3/8" ANGLE DRILL

Model DA3000*

Model DA3000R

SERVICE CHANGES

1. Change on Drill Chuck.

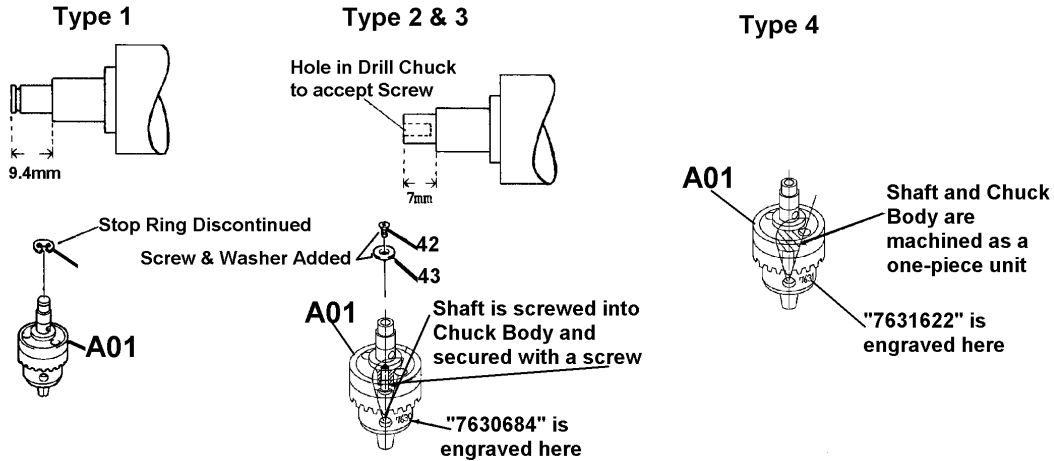
Item No.	Description	Type 1	Type 2	Type 3	Type 4
17	Stop Ring	961013-5	(Discontinued)		
42	(+) Countersunk Head Screw M4x12	- - - - -	251304-5 (Added)		
43	Washer 4	- - - - -	253969-9 (Added)		
A01	3/8" Drill Chuck	763059-5	763068-4		193443-4
	Serial No. DA3000	~ 37373E	37374E ~ April 1993		- - - - -
	Serial No. DA3000R	~ 7020E	7021E ~ 384264E		384265E ~

Above parts are completely interchangeable as a set.

2. Change on Gear Housing and Pin.

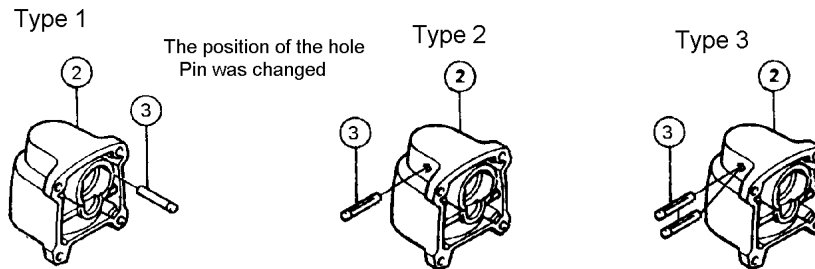
Item No.	Description	Type 1	Type 2	Type 3	Type 4
2	Gear Housing	315267-0 (No Longer Available)	157549-2 (No Longer Available)	159272-5	
3	Pin	256109-8 Pin 4 (2pcs) (No Longer Available)	951129-4 (No Longer Available)	Roll Pin 4-36 (1pc)	Roll Pin 4-36 (2pcs) (White Color)
	Serial No.	~ 57566E	57567E ~	No Type 3 Sold	
	Serial No.	~ 16114E	16115E ~ 139388E	139389E ~ 164679E	164680E ~
					256745-0 Pin 4 (2pcs) (Golden Color)
					No Type 4 Sold

Above parts are completely interchangeable as a set.

3. Change on Hex Bolt/Tapping Screw and Motor Housing.

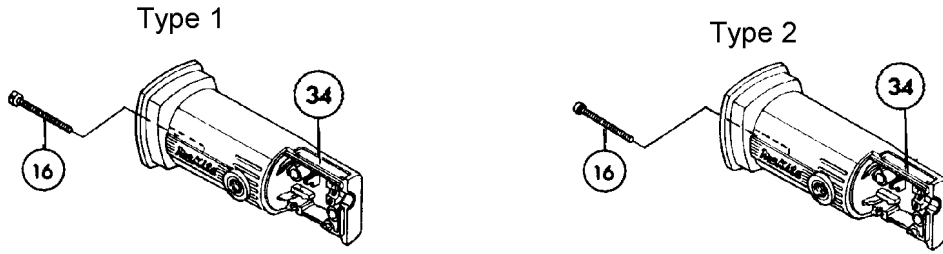
Item No.	Description	Type 1	Type 2
16	Hex Bolt/Tapping Screw	925183-4 - (+) Hex Bolt M4x55	265891-8 - Tapping Screw BT 4x55
34	Motor Housing	156766-1 (DA3000) (No Longer Available) 156804-9 (DA3000R) (No Longer Available)	157720-8 (DA3000) 157722-4 (DA3000R)
	Serial No. DA3000R	~ 45902E	45903E ~

DA3000 has Type 1 only.

4. Change on Gear etc.....

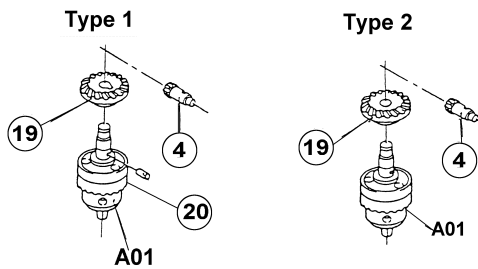
Item No.	Description	Type 1	Type 2
4	Spiral Bevel Gear	221342-1 (10) (No Longer Available)	226751-9 (7)
19	Spiral Bevel Gear	221343-9 (36) (No Longer Available)	226752-7(24)
20	Pin 5	256023-8	-----
	Serial No. DA3000	---	---
	Serial No. DA3000R	~269705E	269706E ~

DA3000 Tools sold in Canada have only Type 1 Parts.
Above parts are completely interchangeable as a set.
